Access Compliance Report

Public Rights-of-Way

(Curb Ramps)

Intersection ID: 10888	Main Street: DRUMMOND_AV	Cross Street: PINCKNEY_AV	Location: S
ADA ID: 6C3C93D883D3	Ramp Type: Perp	Initial Pass/Fail: Fail	Overall Compliance: No
Severity Score: 61.25			
Codes/Mitigation Info/Possible Solution		Field Measurements/Component Compliance

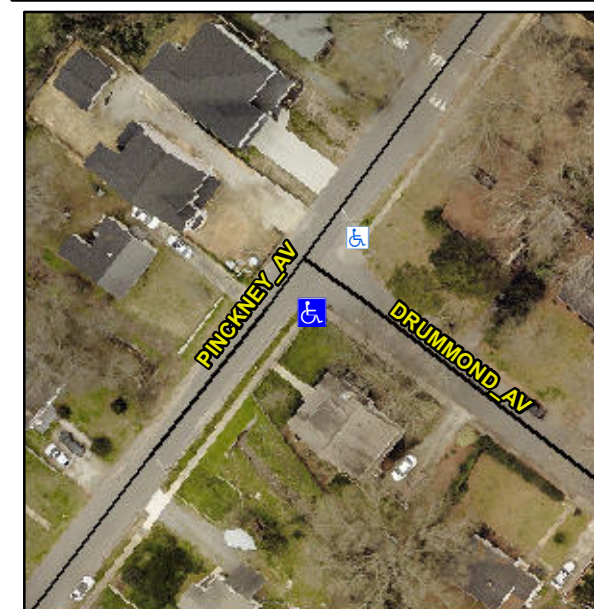
Not Found, R304.5.1, R304.2.2, R304.5.3

Compliance	Description	Data	Compliance	Description	Data
N/A	Ramp Length (in)	41.0	No	Ramp Slope (%)	15.8
No	Ramp Width (in)	25.0	No	Ramp XSlope (%)	2.3
N/A	Flare Type LT	N/A	N/A	Flare Type RT	N/A
N/A	Flare Slope LT (%)	N/A	N/A	Flare Slope RT (%)	N/A
N/A	Flare Traversable LT?	N/A	N/A	Flare Traversable RT?	N/A
N/A	Landing Length (in)	N/A	N/A	DWS Provided?	N/A
N/A	Landing Width (in)	N/A	N/A	DWS Contrast?	N/A
N/A	Landing Slope (%)	N/A	N/A	DWS Length (in)	N/A
N/A	Landing X Slope (%)	N/A	N/A	DWS Full Width?	N/A
N/A	Landing Curb? (Y/N)	N/A	N/A	DWS Offset (in)	N/A
N/A	Shared Landing?	N/A			
N/A	Gutter Ponding?	N/A	N/A	Gutter Slope (%)	N/A
N/A	Gutter Lip Ht (in)	N/A	N/A	Gutter X Slope (%)	N/A
N/A	Painted X Walk1?	No	N/A	Painted X Walk2?	N/A
	X Walk 1 Direction	To NE		X Walk 2 Direction	N/A
N/A	X Walk 1 Width (in)	N/A	N/A	X Walk 2 Width (in)	N/A
	X Walk 1 Slope (%)	3.6		X Walk 2 Slope (%)	N/A
	X Walk 1 X Slope (%)	3.7		X Walk 2 X Slope (%)	N/A

Remove & Replace Entire Ramp.
